North Liberty Planning Commission
Tuesday, September 1, 2020, 6:30 PM

To **City of North Liberty Planning Commission**
From **Ryan Rusnak, AICP**
Date **August 28, 2020**
Re **Request of Cherry Pig LLC to approve a Preliminary Plat for a two lot subdivision at 135 Cherry Street.**

To **City of North Liberty Planning Commission**
From **Ryan Rusnak, AICP**
Date **August 28, 2020**
Re **Request of Casey's Marketing Company to approve a Site Plan on 1.58 acres for the redevelopment of the property located at 600 Westwood Drive and 230 Sugar Creek Lane.**

To **City of North Liberty Planning Commission**
From **Ryan Rusnak, AICP**
Date **August 28, 2020**
Re **Request of the City of North Liberty for an ordinance amending Section 167.01 of the North Liberty Code of Ordinances, entitled “Definitions” and various sections in Chapter 169 of the North Liberty Code of Ordinances, entitled “Development Regulations”.**

DESCRIPTION - CLIFF JUMPING SHEEP SUBDIVISION

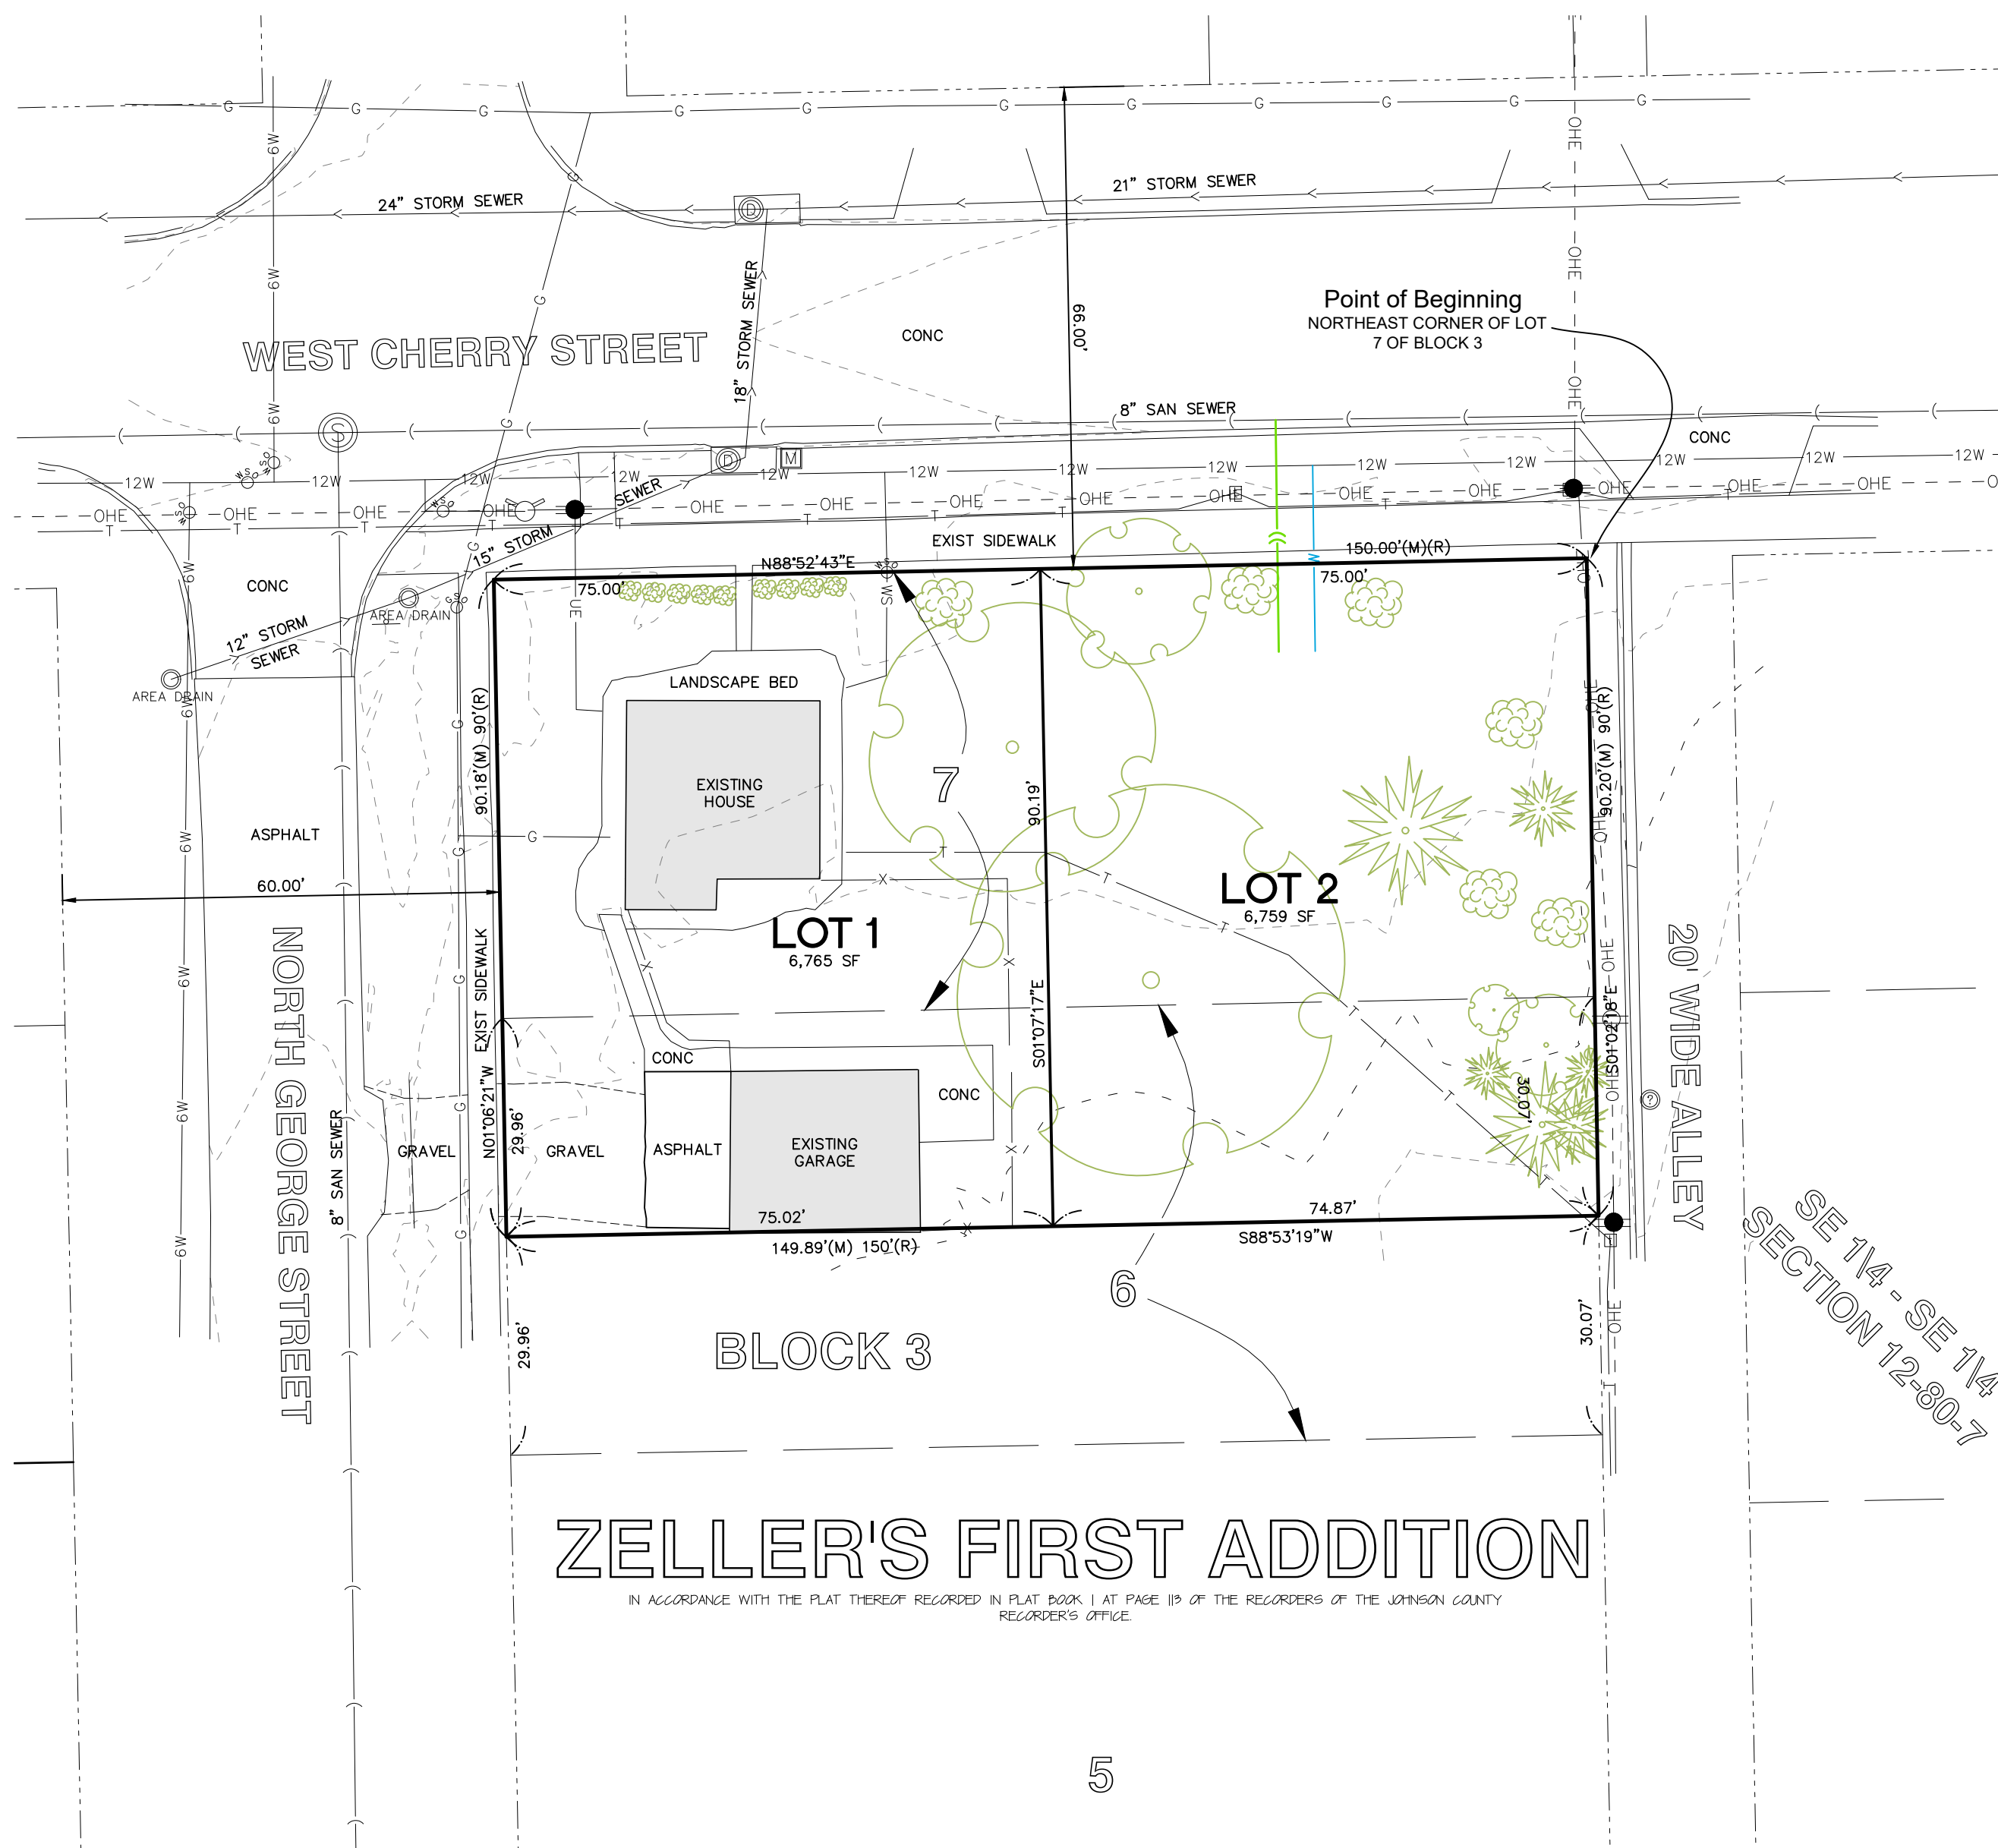
The preliminary plat proposes to re-subdivide Lots 6 and 7, Block 4 of Zeller's 1st Addition into two lots.

The RS-8 zoning is not consistent with the Commercial Land Use Designation.

Staff recommends the Planning Commission accept the listed finding and forward the request of Cherry Pig LLC to approve a Preliminary Plat for a two lot subdivision at 135 Cherry Street.

N. DAY	1"=20'	8.27.2020
C-100 - DEMO PLAN		20-019

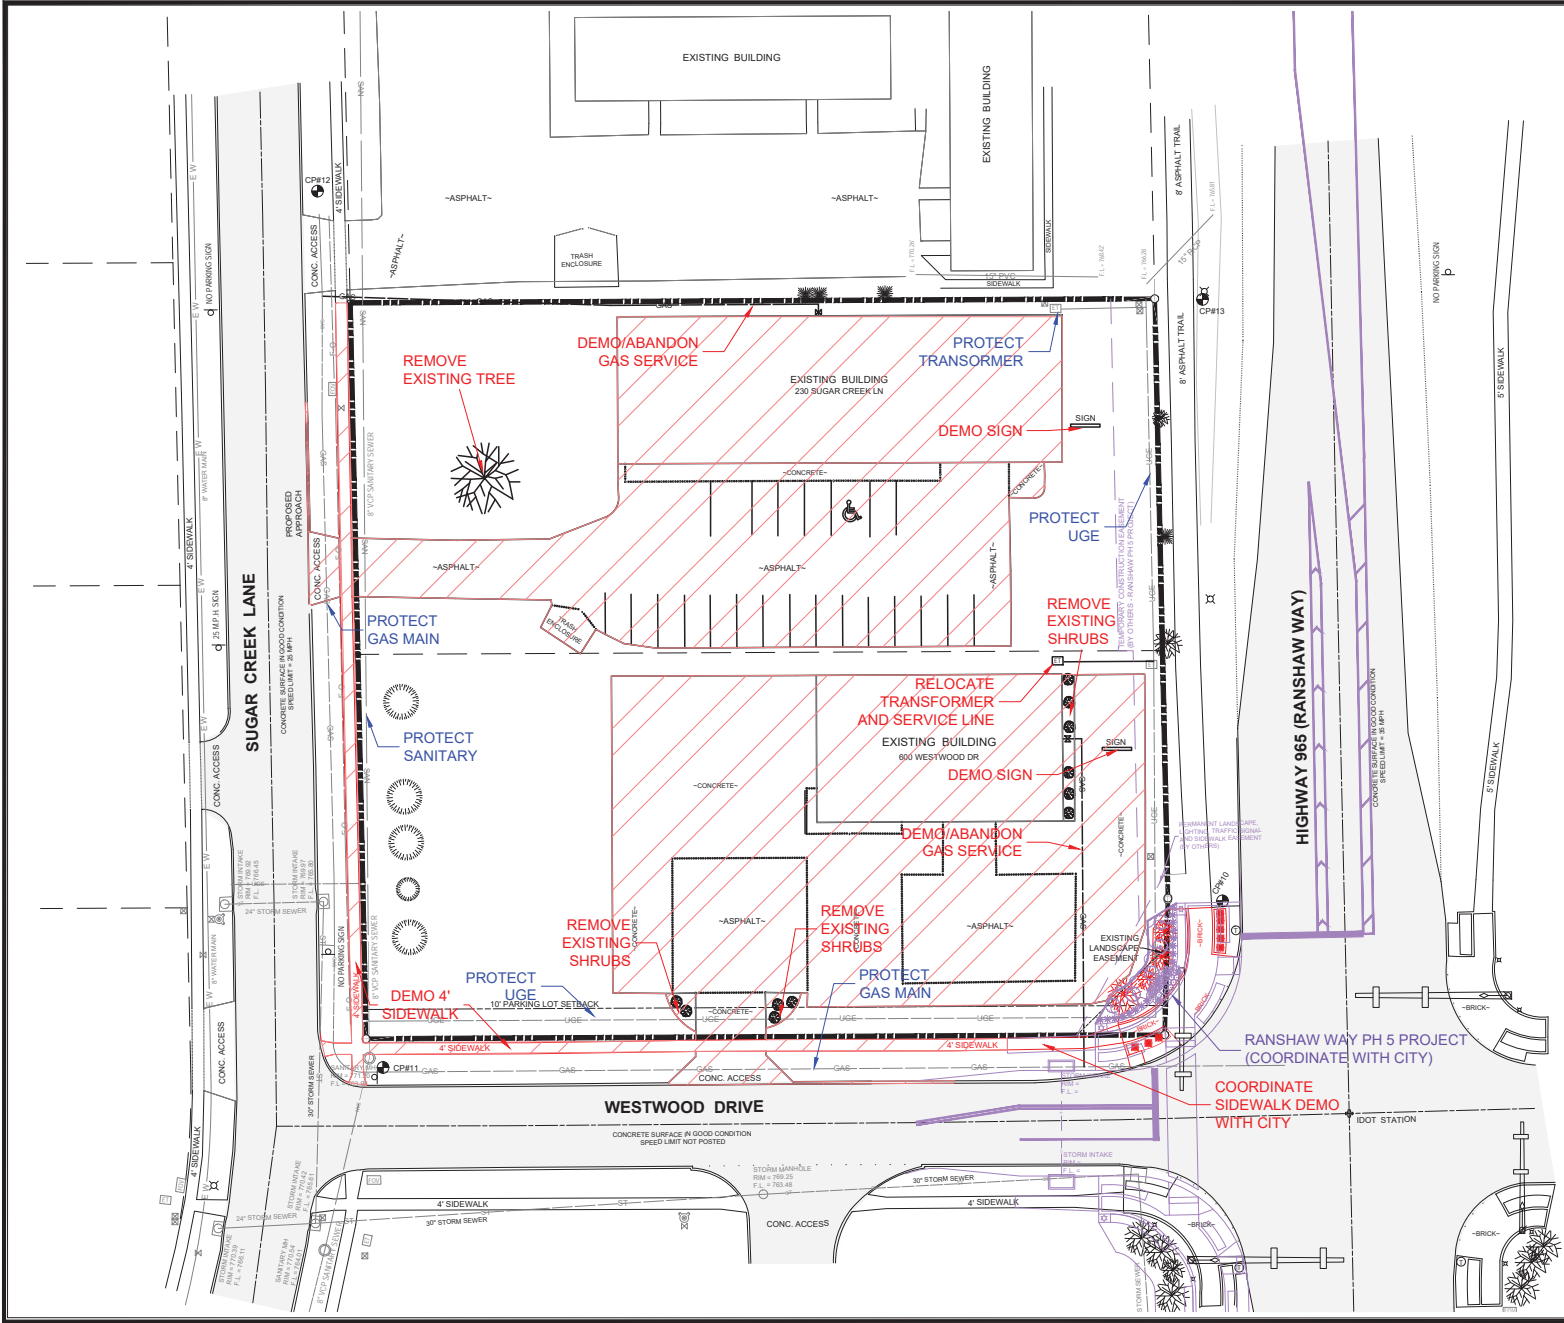
- (9) *Existing buildings, right-of-way, street improvements, utilities (overhead or underground), easements, drainage courses, vegetation and large trees, etc.*
This information has been provided on sheet C-100.

C:\2020 Projects\20-019 - Casey's North Liberty 600 Westwood Dr\Engineering\Site Plan\Sheet Set C-101 - LAYOUT PLAN

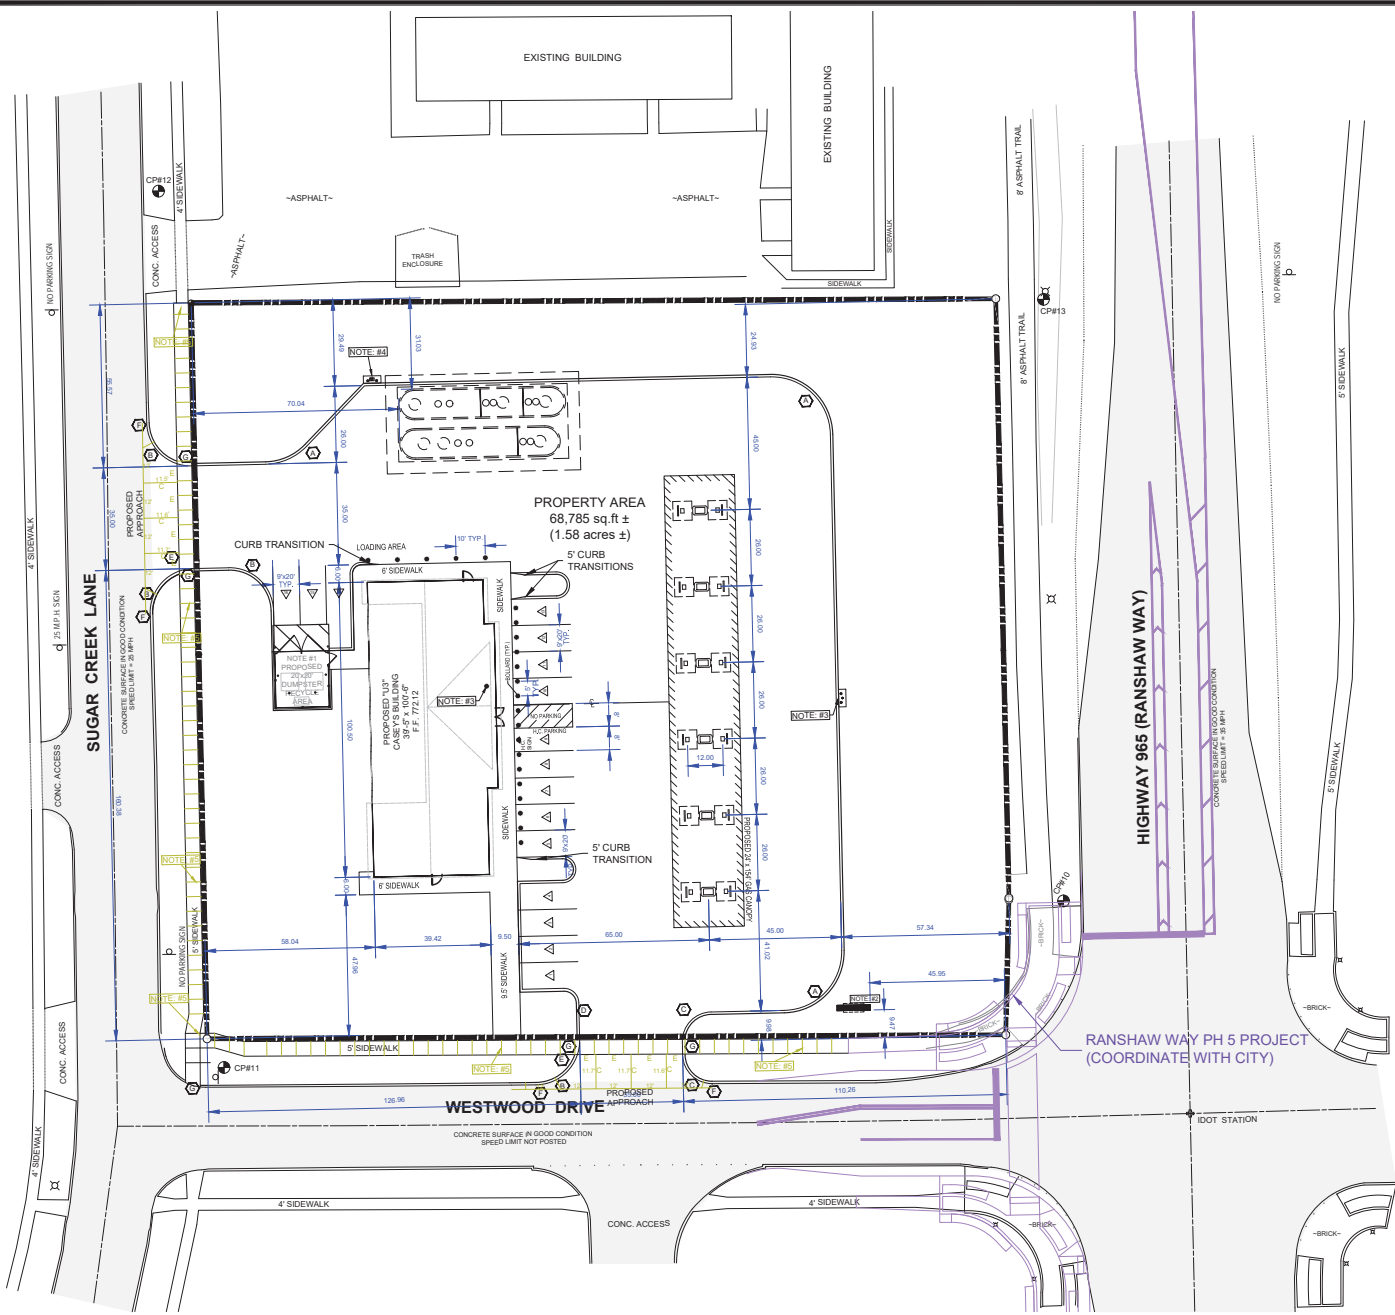
- (4) *The proposed location, size, shape, color, and material type of all buildings or structures.*
This information has been provided on sheet C-101, on sheets A-201 and A202 and canopy and sign renderings.

- (11) *Walkways, driveways, outside lighting, walls, fences, signs, monuments, statues and other manmade features to be used in the landscape.*
Walkways and driveways are shown on sheet C-101. Notably, the 4' wide sidewalks would be replaced with 5' wide sidewalks. A lighting plan has been provided. Staff is recommending that the lighting be adjusted so it does not exceed one footcandle along the west property line, consistent with Section 169.12(1)(5) of the North Liberty Code of Ordinances. No walls, fences, monuments or statues are proposed.

©2020 Project 20-019 - CCS North Liberty 600 Westwood Dr/Engineering/Els Design Ser. C-701 - LANDSCAPING PLAN

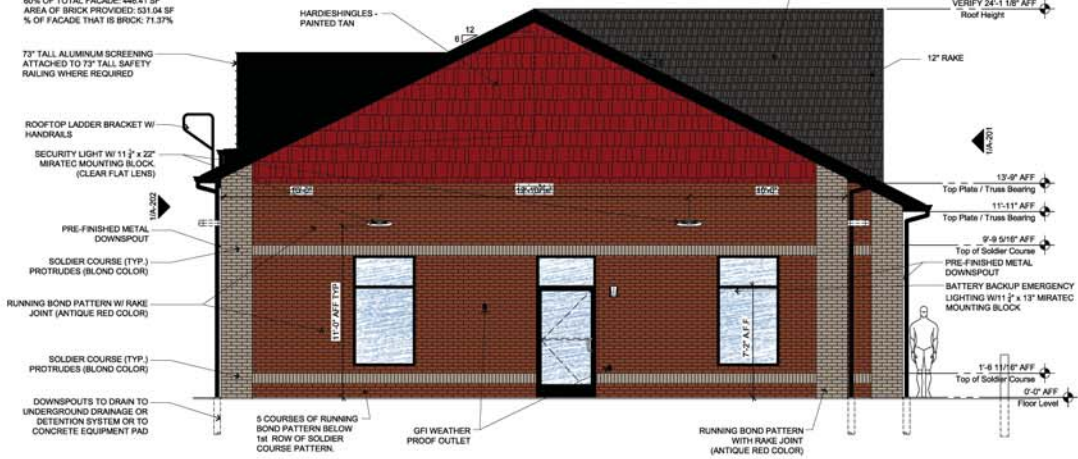
- (12) *Location and type of all plants, grass, trees, or ground cover to be used in the landscape. Landscaping shall be illustrated in elevation and color perspective with the size and exact names of plants, shrubs, or trees to be planted clearly indicated.*
This information has been provided on sheet C-701 on the color perspective.

600 WESTWOOD DRIVE NORTH LIBERTY, IA	01/09/20 03/09/20 08.24.20	EXTERIOR ELEVATIONS
CONSTRUCTION DIVISION Drawn by: BRYAN RAIN		A-201

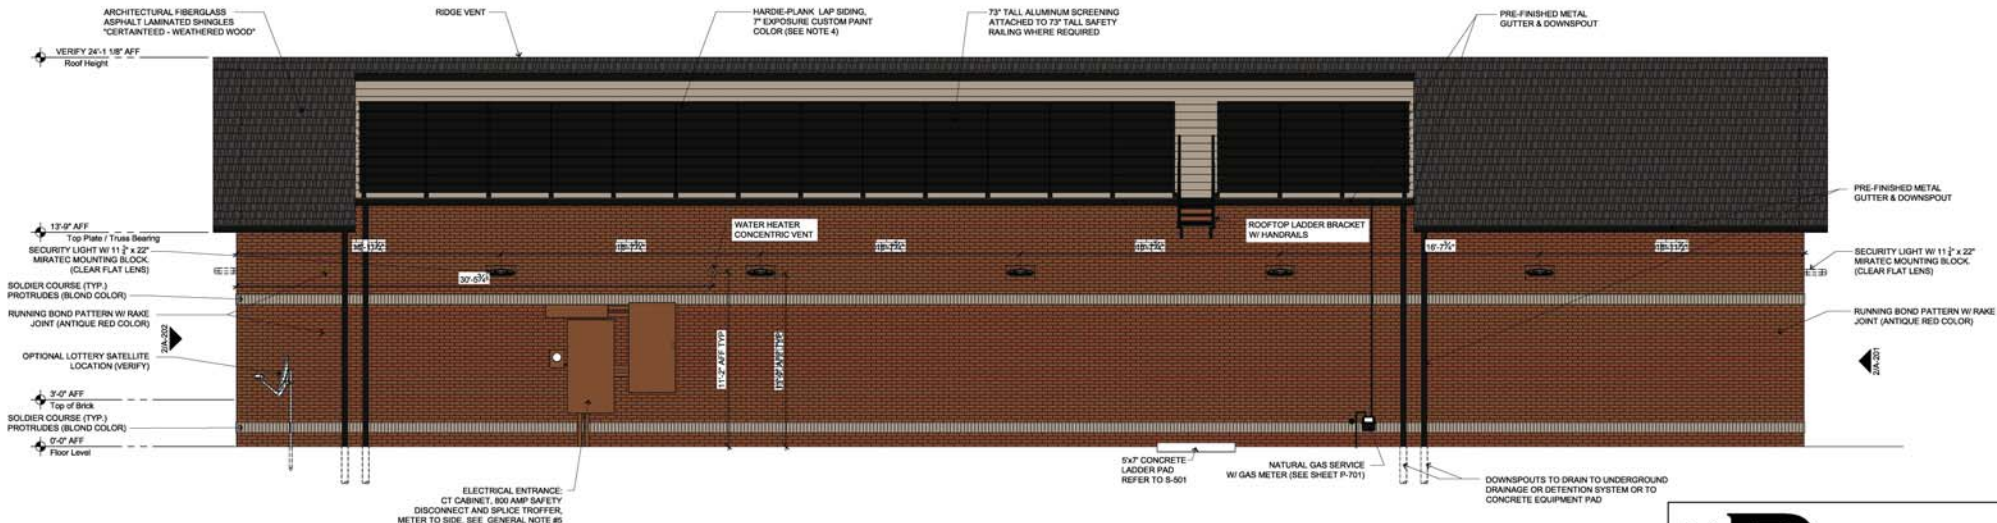
- (7) *The proposed location of identification signs. An identification sign is defined as a sign displaying the name, address, insignia or trademark, and occupant of a building or the name of any building on the premises. Installation shall be in accordance with the Chapter 173 of this code.*
The ground sign is referenced on sheet C-001 and the location is shown on sheet C-101. Building mounted signage is shown on sheet A-201. A sign package has also been provided.
